RE: Remarkables Ski Area Upgrades and Doolans Expansion – Response to Landscape Feedback

PEER REVIEW MEMORANDUM REGARDING LANDSCAPE AND VISUAL EFFECTS ASSESSMENT

DOC Memorandum on NZSki Landscape Effects Assessment

REMARKABLES SKI DOOLANS EXTENSION

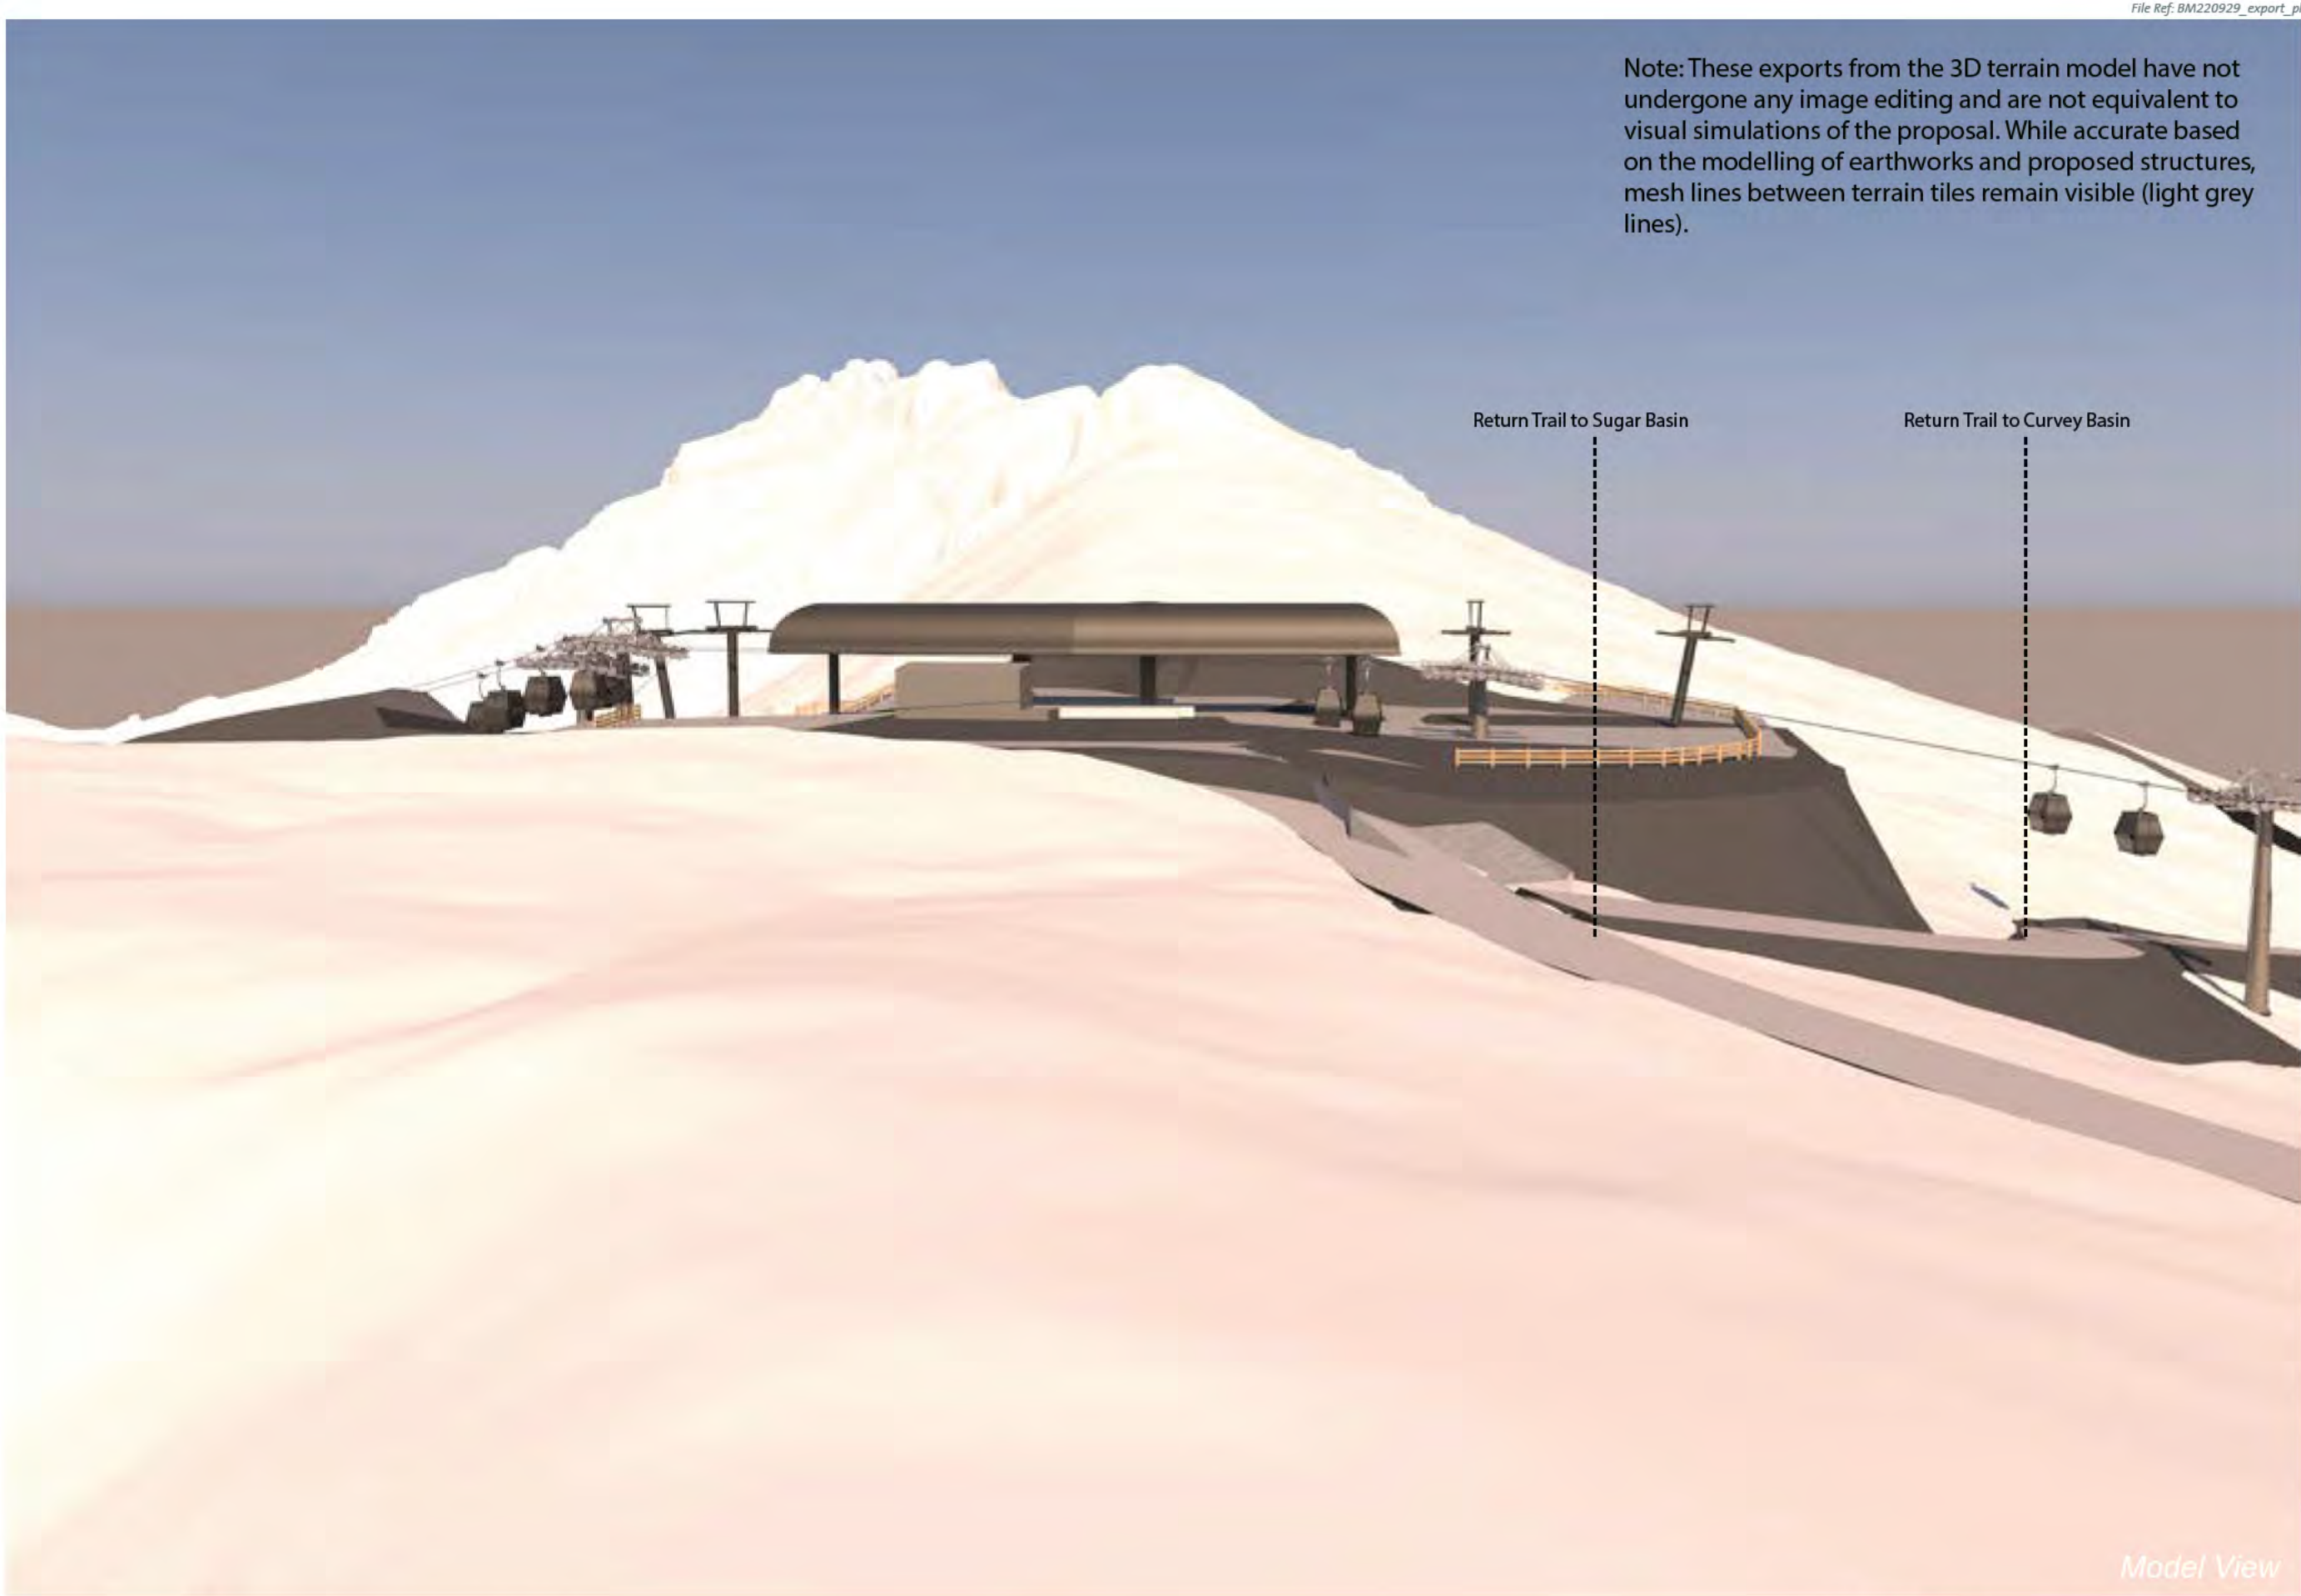
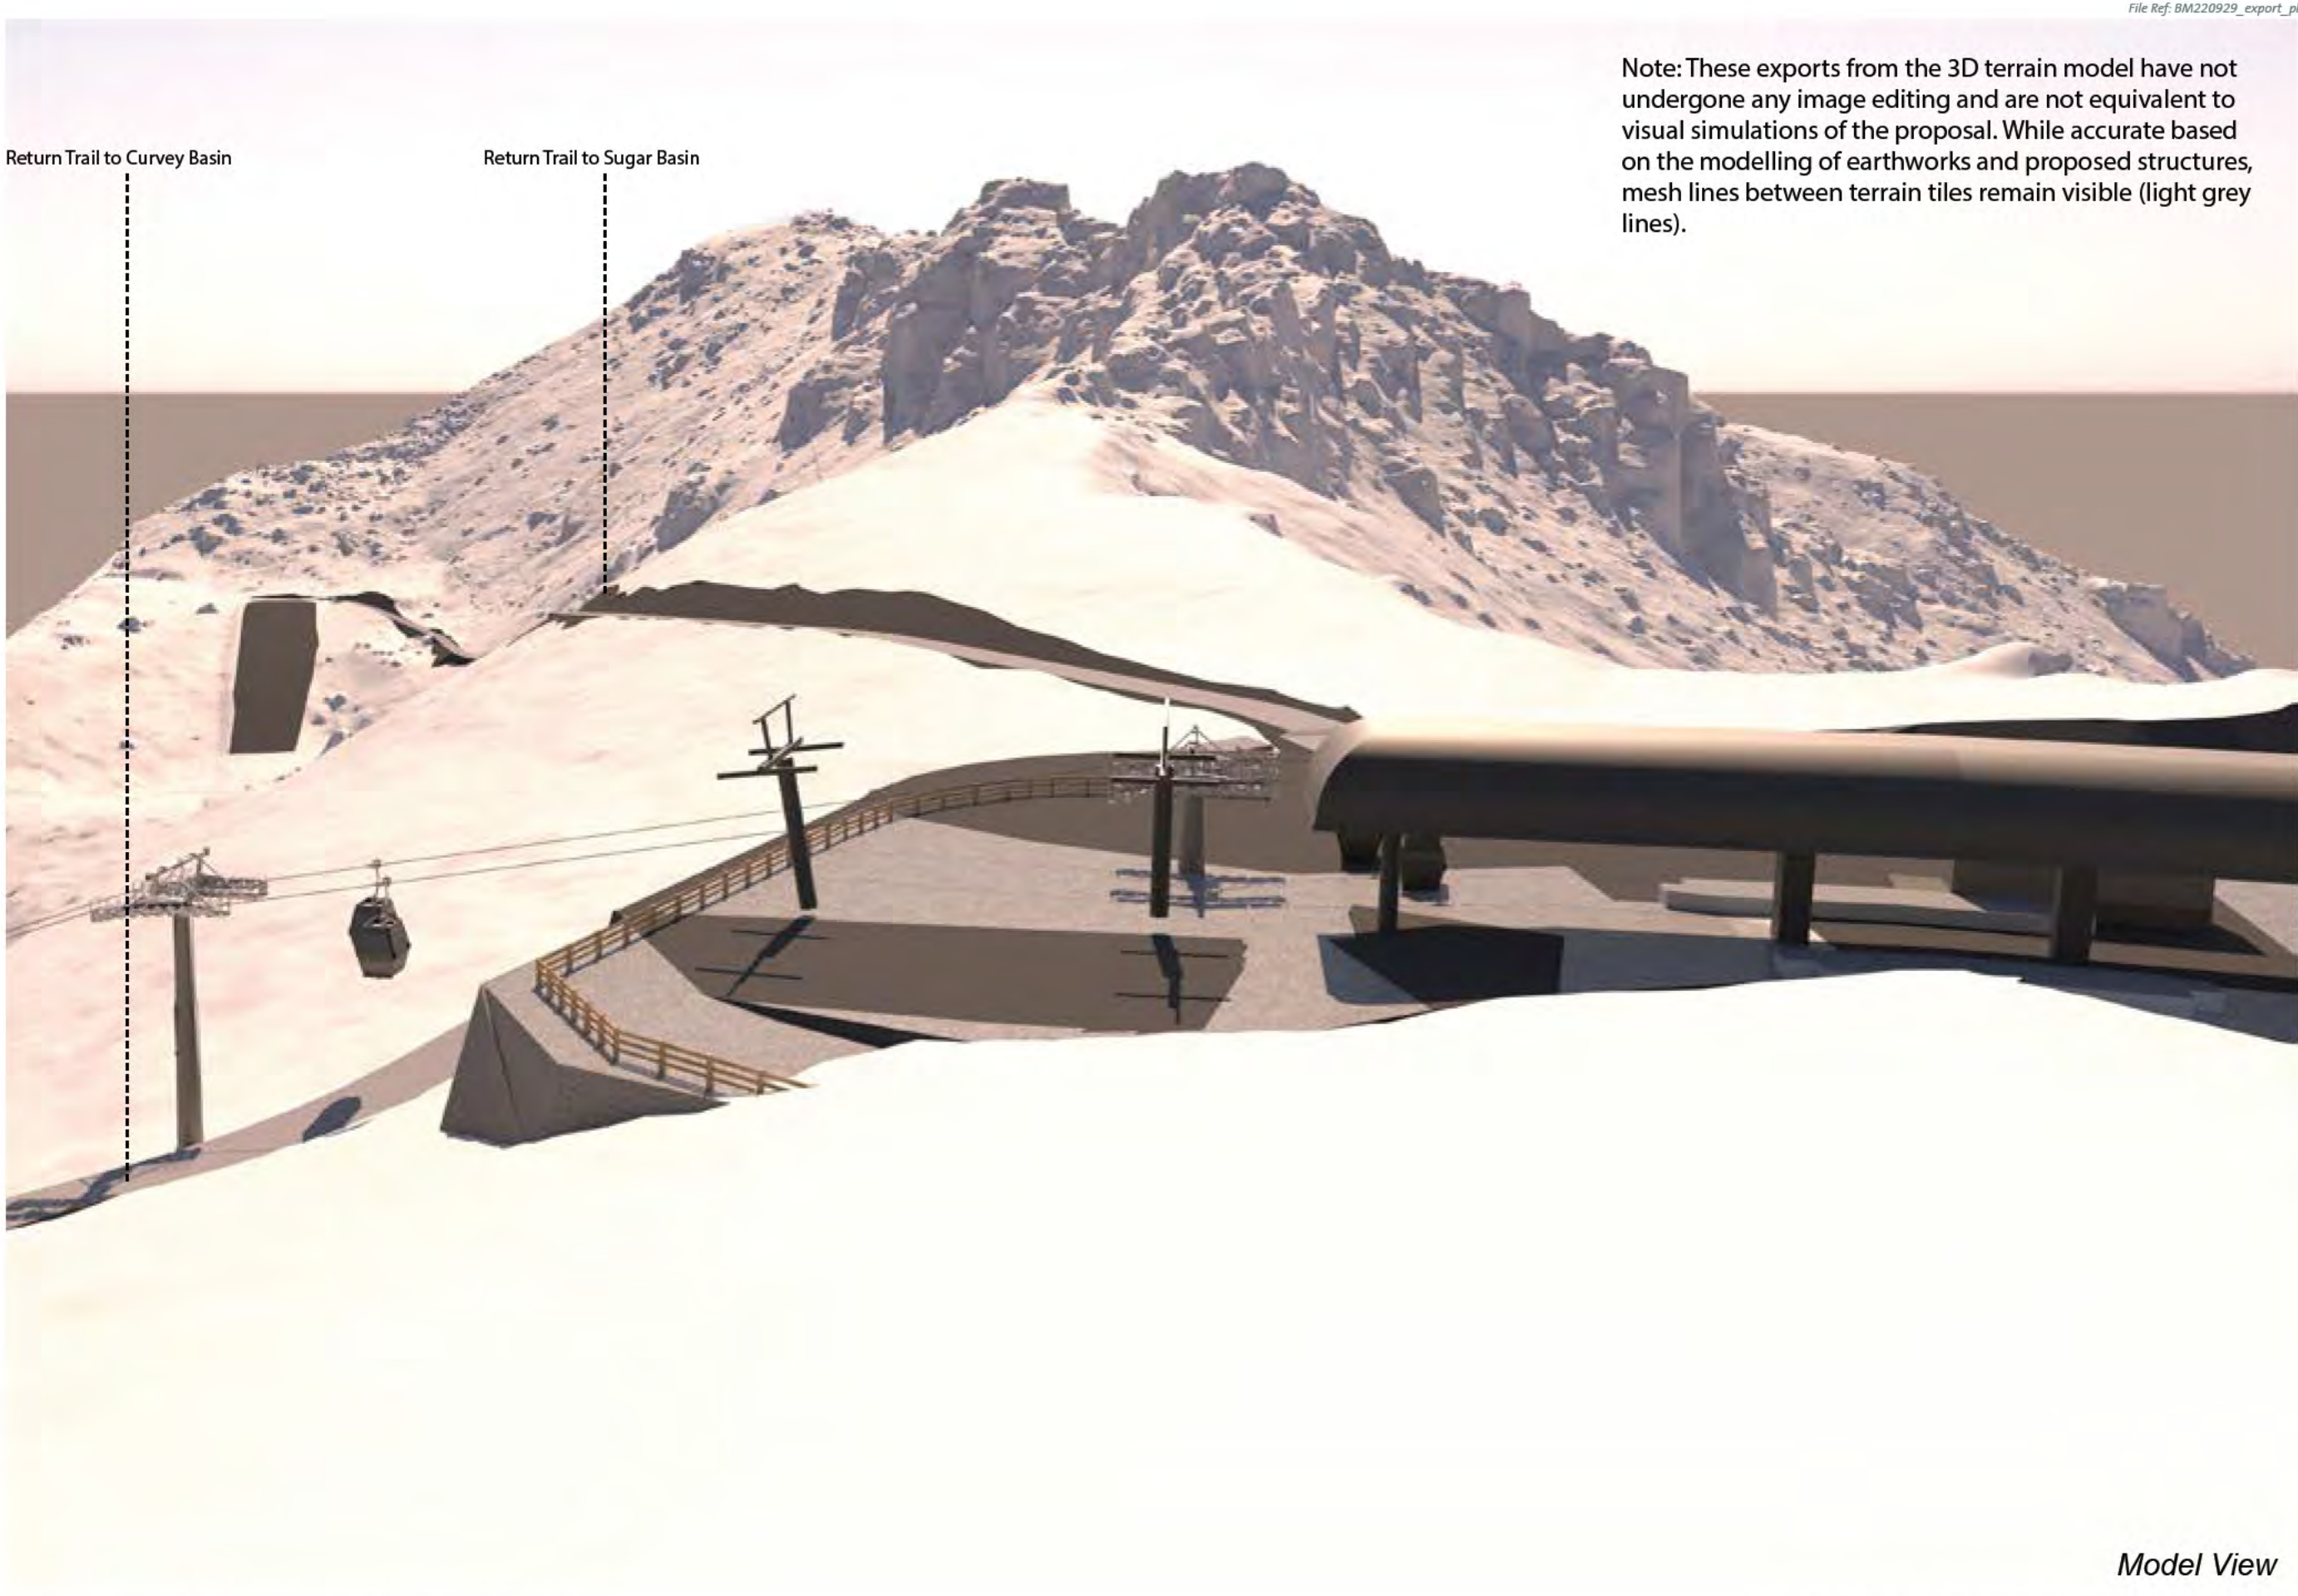
2. NZSki to provide views of the proposed mid-station in relation to the surrounding landform and landscape context.

19. The mapping in the 6 May 2026 B-031.1 Remarkables Ski Area Upgrade and Doolans Expansion Landscape Graphics (Figures 1, 2 and 4) is at a scale / level of detail where it is difficult to see where the proposed gondola mid-station is located. It is important that the various areas (QLD area and its mapped SASZ, the COD area, Rastus Burn Recreation Reserve and ridgeline) are accurately mapped along with the location of the mid-station building.

- > See attached Boffa Miskell memo and graphic supplement (**Attachment 3**)

The additional exports show both the mid station building and the earthworks required to establish the structure, including the proposed retaining walls and lift towers. In views within the ski field (see pages 1-10) the platform/retaining wall and lift tower will partially appear on the skyline, with the midstation structure itself largely out of view. For more distant views, the midstation will partially appear on the skyline (see visual simulation 3). However, in these views the structure is a comparatively small element.

On the Doolans side of the ridge the midstation is within a up to 10m high cut, but in nearby views from immediately below the structure (see Model view p.18) the mid station would protrude on the skyline. However, as shown in the ZTV, the mid station is obscured from substantial parts of the Doolans basin by intervening ridgelines. Pages 13-16 illustrate views of the mid station in views along the ridgeline to show the cut (Doolans side) and fill (Rastus Burn side) required to construct the platform. It is acknowledged that the visual effects of the mid station will be high when viewed within its immediate context along the ridge or from immediately below on the Doolans side. However, I maintain the view that visual effects of the mid station from the Rastus Burn side are mostly moderate, as the retaining wall partially obscures the structure in short-distance views and in long-distance views the structure is a relatively small element on a rocky ridgeline.
